ORIGINATION FORM

Proposed Revisions to a Standard Plans Index
(Please provide all information — Incomplete forms will be returned)

Index Number: 102-604
Sheet Number (s): 1 and 2 of 2
Index Title: Two-Lane, Two-Way, Intersection Work

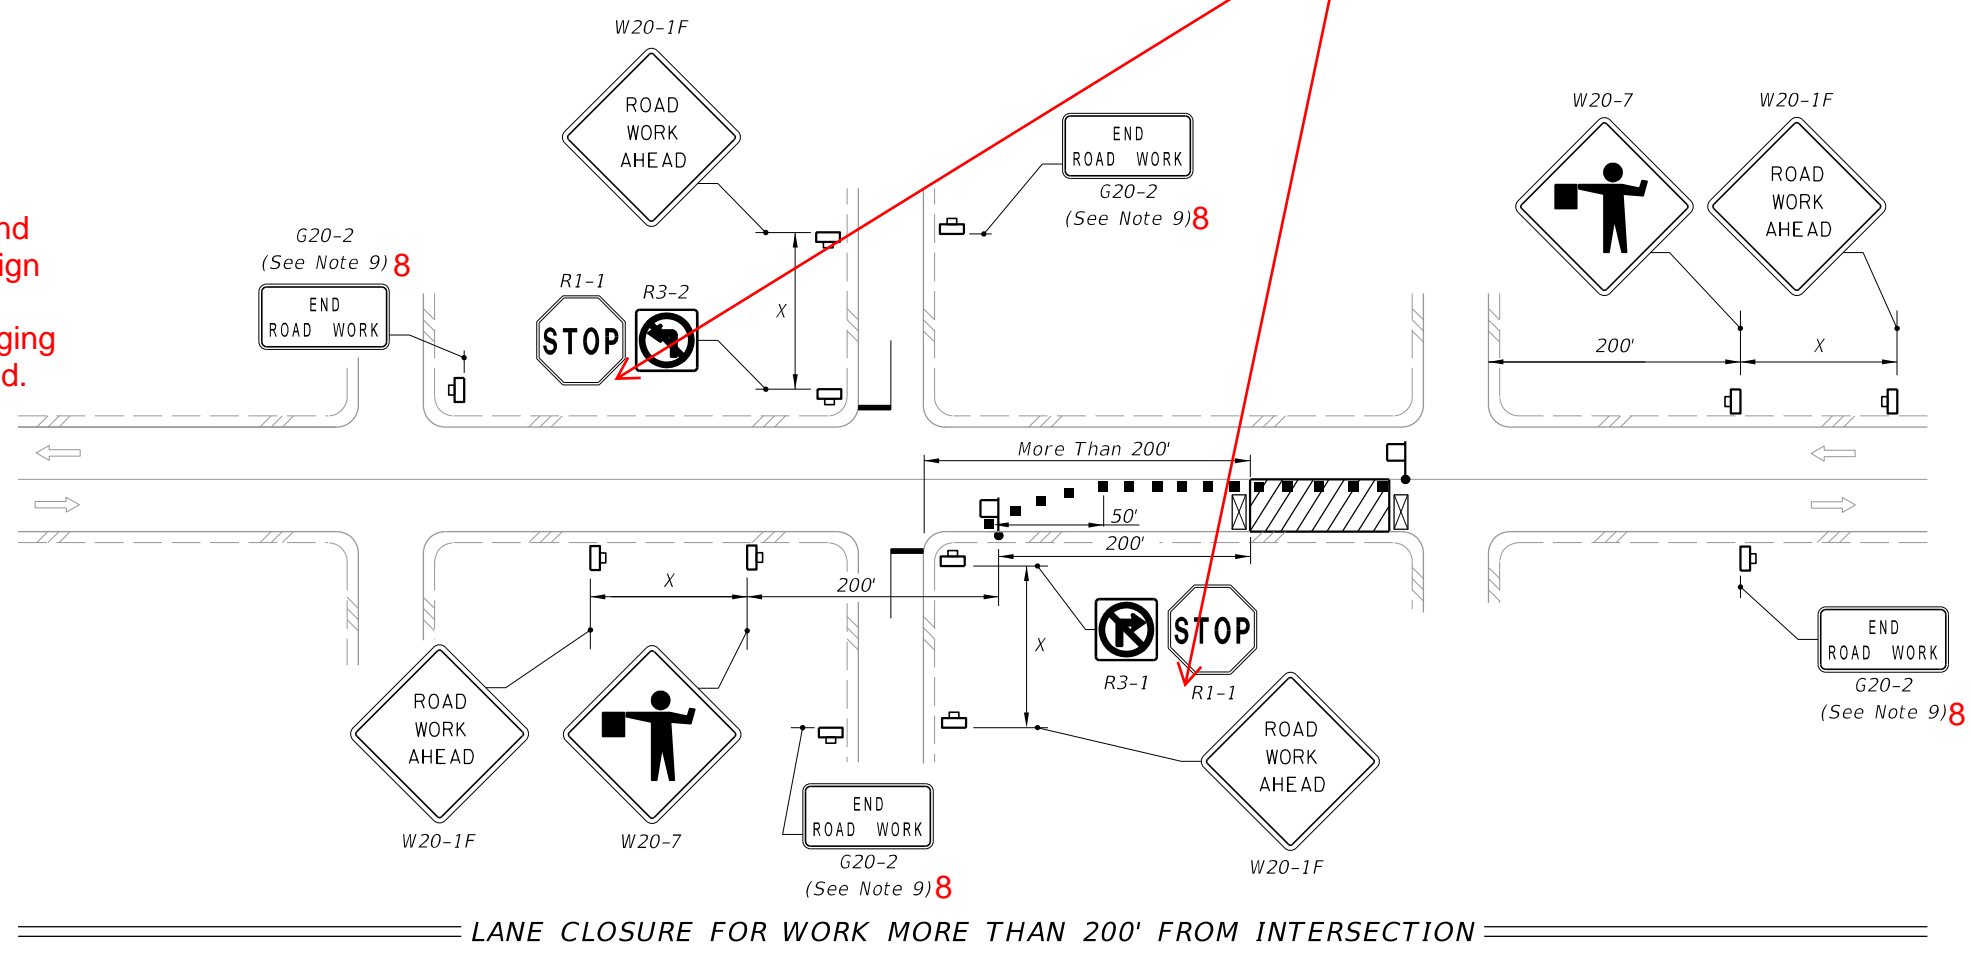
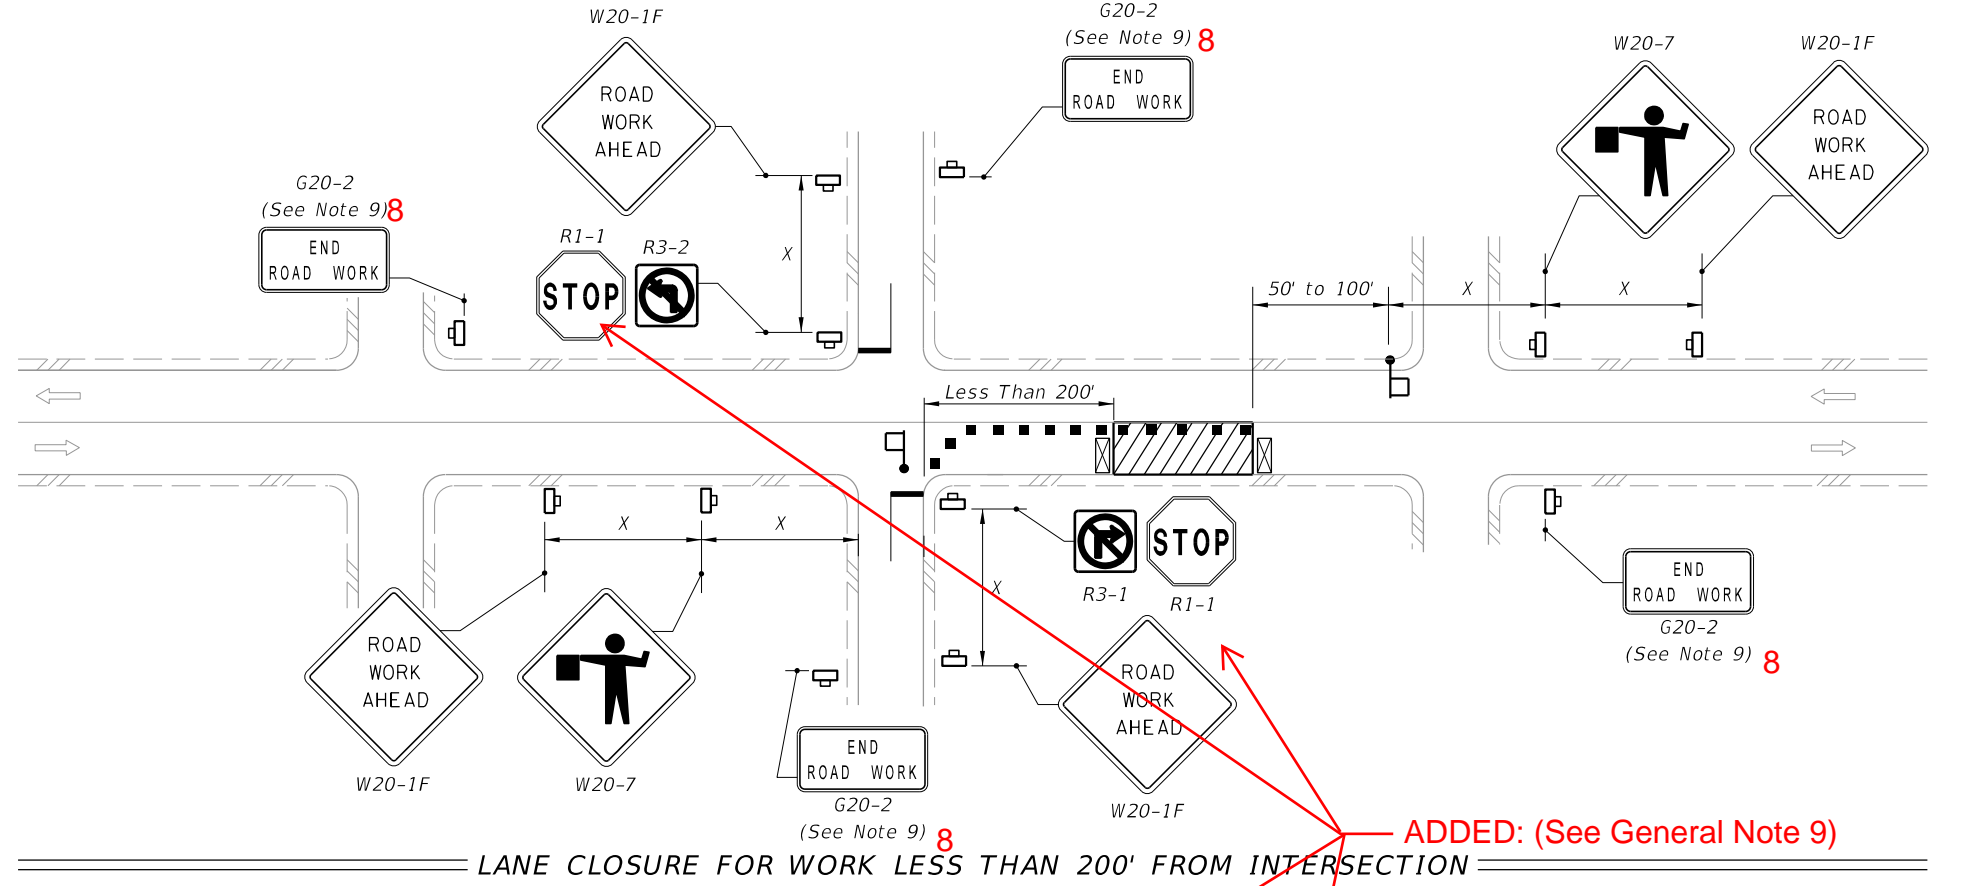
Sheet 1: Deleted Note 9; Added New General Note 9: "As an option to the "STOP" sign (R1-1) and Restricted Left/Right Turning Movement sign (R3-1 or R3-2), the "SIDE ROAD INTERSECTING THE WORK ZONE" flagging operation from Index 102-600 may be used.". Added (See General Note 9) at intersections with R1-1 and R3-2 signage.

~~9. If the work encroaches on a marked bicycle lane or rideable shoulder, close the lane or shoulder in accordance with the Plans.~~

9. **DELETED: Note 9.**

ADDED New Note:
As an option to the "STOP" sign (R1-1) and Restricted Left/Right Turning Movement sign (R3-1 or R3-2), the "SIDE ROAD INTERSECTING THE WORK ZONE" flagging operation from Index 102-600 may be used.

ADDED: (See General Note 9)

Note 9 was added to help clarify that the side road flagging index can be used instead of the sign layout shown at the side road intersections. The flagger was moved to be in the correction position on the roadway.

WORK IN INTERSECTION OF TWO-LANE ROADWAY

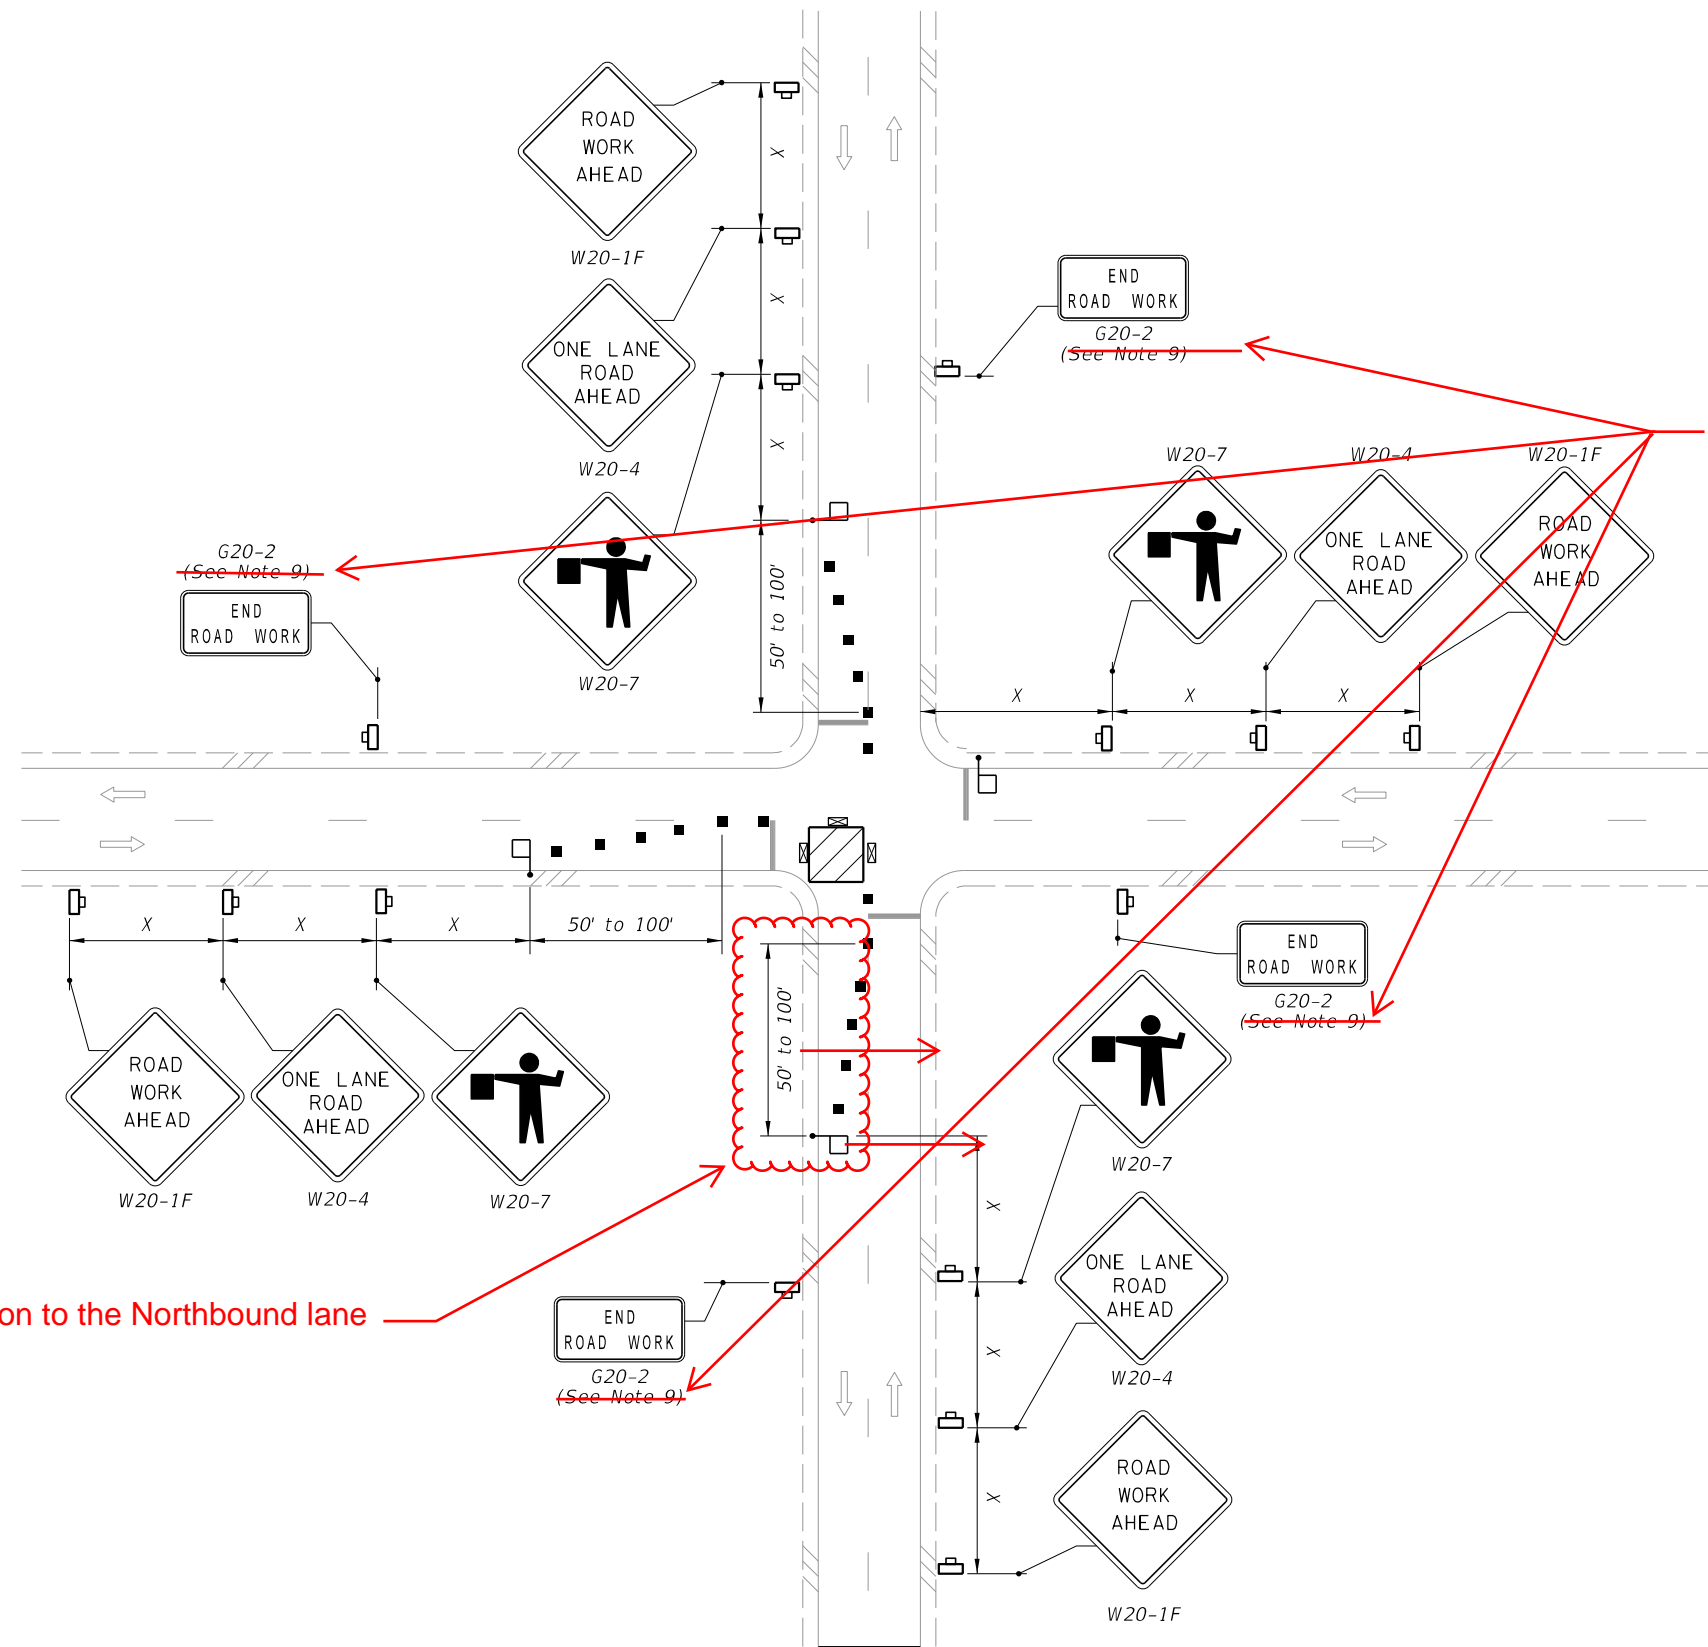
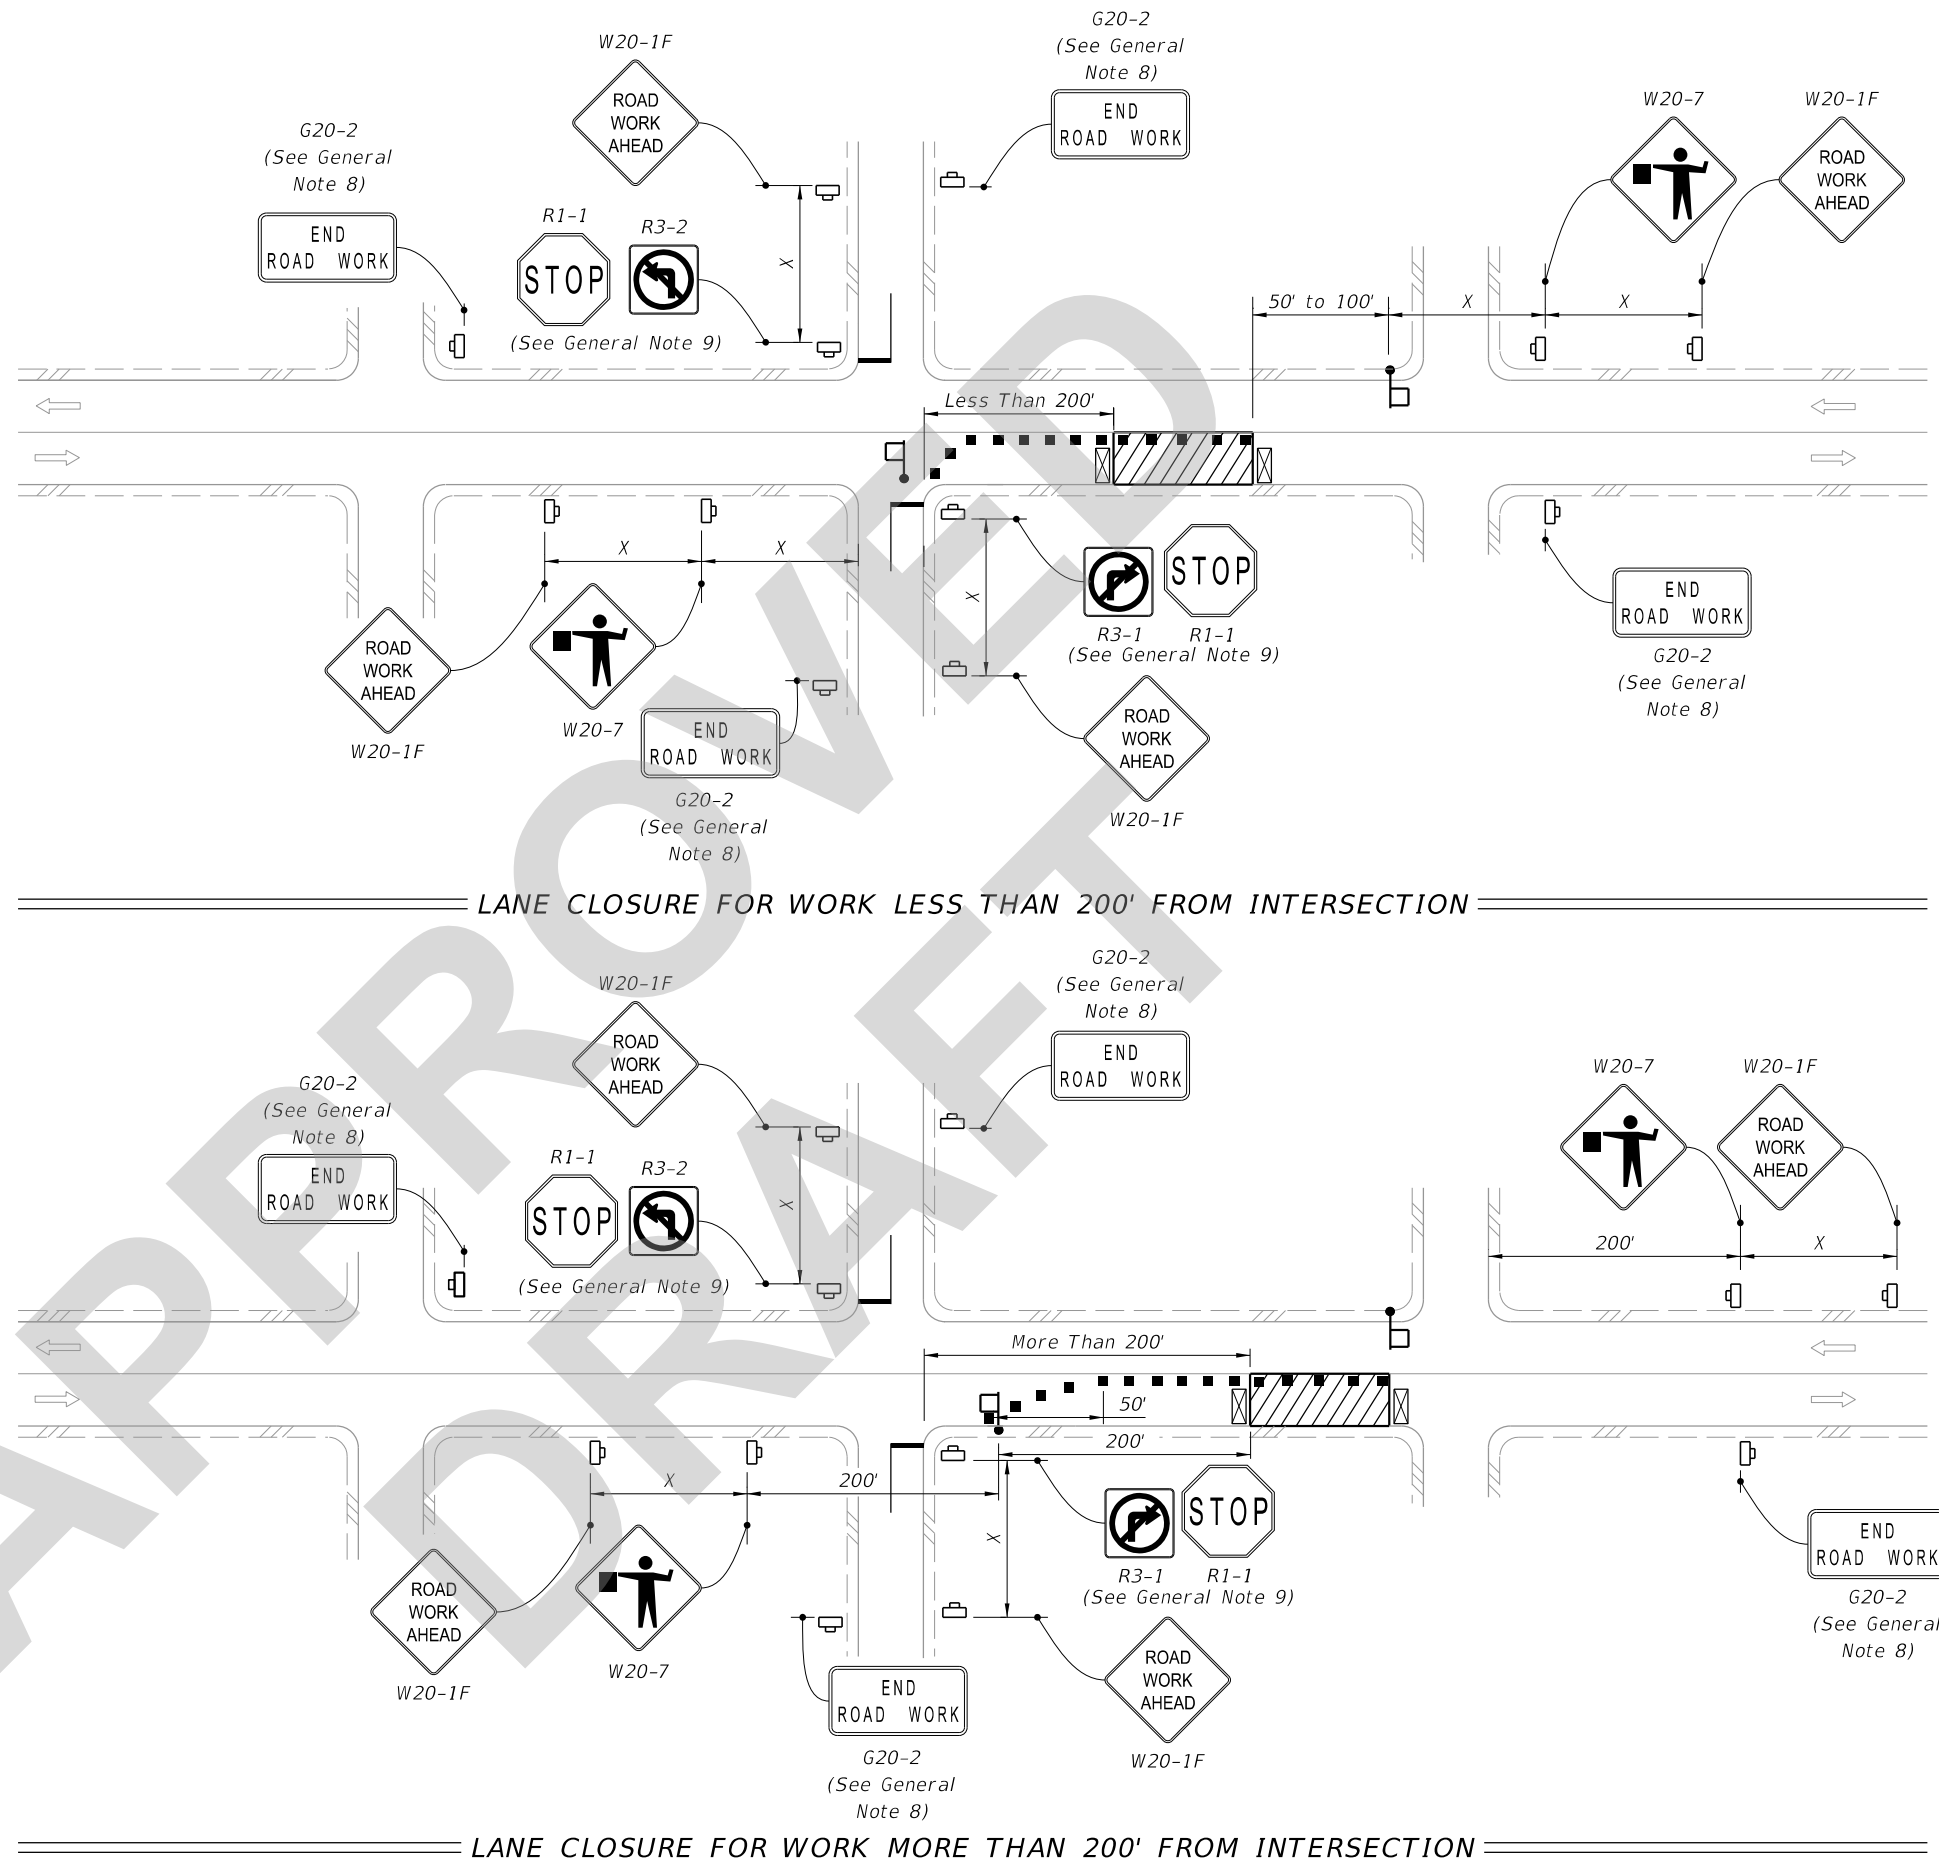
Sheet 2: Moved the Flagger and associated dimension on the Southern lanes of the detail, from the southbound lane to the northbound lane.

MOVED: Flagger and Dimension to the Northbound lane
